**Subject:** MHI's Responses to US-APWR DCD RAI No. 490-3732

**Reference:** 1) "Request for Additional Information No. 490-3732 Revision 0, SRP Section: 03.08.01 - Concrete Containment," dated 11/23/2009.

**US-APWR Design Certification  
Mitsubishi Heavy Industries  
Docket No. 52-021**

**RAI NO.:** NO. 490-3732 REVISION 0  
**SRP SECTION:** 03.08.01 - Concrete Containment  
**APPLICATION SECTION:** 3.8.1  
**DATE OF RAI ISSUE:** 11/23/2009

Figure 1 After Terzaghi & Peck (1968).

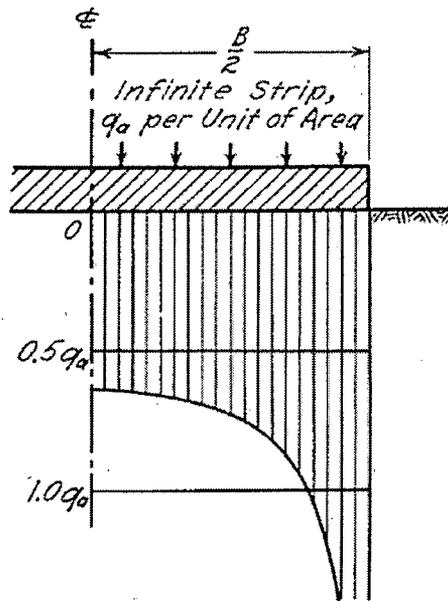
2. For Part (b), MHI presents the soil spring constant for each of the three directions per unit area for the FE model in Table 1. These spring constants are the average values over the entire basemat of the dynamic soil springs calculated based on the American Society of Civil Engineers (ASCE) 4-98. The staff finds that MHI's approach is unacceptable because these springs do not reproduce the theoretical distribution of the soil pressure for a uniform displacement of the foundation. Further, MHI is requested to check the units for the vertical spring constant for Method 2,  $k_{v2}$ , mentioned in their response, and provide an explanation for why it does not depend on the angle of rotation. Does  $k_{v2}$  have the tension capability? MHI is also requested to provide the criteria for "lift off" used in the analysis and explain the meaning of "Main loading direction" stated in Table 2 of their response. Are there any minor loading directions? If yes, please describe them. Are vertical soil springs used for any minor loading directions?

1. Mat vs. soil/rock stiffness. Mats that are very stiff with respect to the soil have a relatively uniform settlement over the entire area, with varying contact pressures (see Figures 1 and 2 below). Very flexible mats act like loaded surfaces, with approximate uniform distribution of contact pressures and non-uniform settlements. In each case, the resulting spring stiffness will be non-uniformly distributed over the mat surface.

**Figure 1 Plan Detail of Typical Buttress**

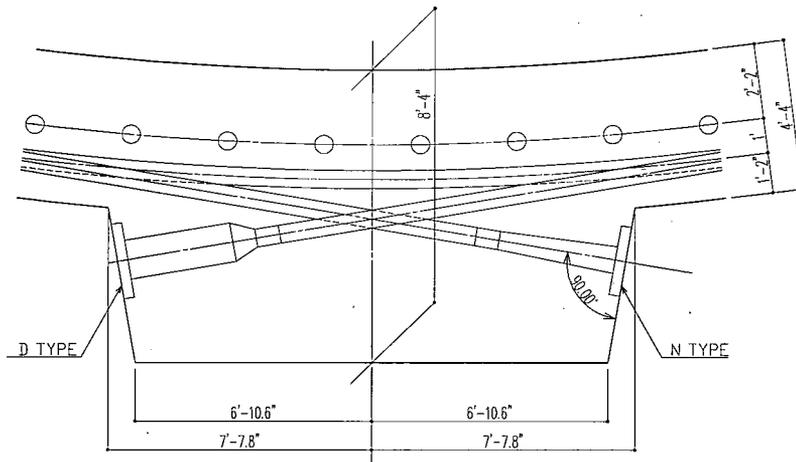
In general, MHI's response is reasonable and acceptable to the staff. However, in Part (b) of the MHI's response, MHI states that "The thickness of the buttress shell elements is 92" which is 40" thicker than the cylindrical wall elements. The centerlines of the buttress elements are accordingly offset from the centerlines of the wall elements. Therefore, the discontinuity effects of the buttresses are captured automatically by the global FE model analyses." The staff notices that MHI used the computer code ANSYS Release 11 (DCD Reference 3.8-14) to check the NASTRAN results.

The staff is aware that ANSYS (Release 11) will not automatically account for the discontinuity effects due to the offset of the centerlines. Therefore, MHI is requested to provide information that shows how discontinuity effects are captured automatically in the ANSYS analysis.

PCCV cylinder wall. See Figure 1 below. This offset results in a difference in centerline position of  $100''/2 - 52''/2 = 24''$ . The previous NASTRAN 3-D FE model performs stress analysis of the cylindrical wall and buttresses using shell elements at the location of the wall center with offset defining function of NASTRAN itself for buttresses. Therefore, in the case of NASTRAN, the offset effects of the buttresses are captured automatically by the global FE model analyses.

In order for the ANSYS analysis model to account for the discontinuity effect, plate elements which reflect a more realistic geometry and thickness will be placed at the centerline of the buttress. The shell elements with variable thickness at nodes will be used to represent the continuity of the wall to the buttress. Forces and moments will be applied to the centerline of the elements to represent the post-tensioning forces on the tendons.
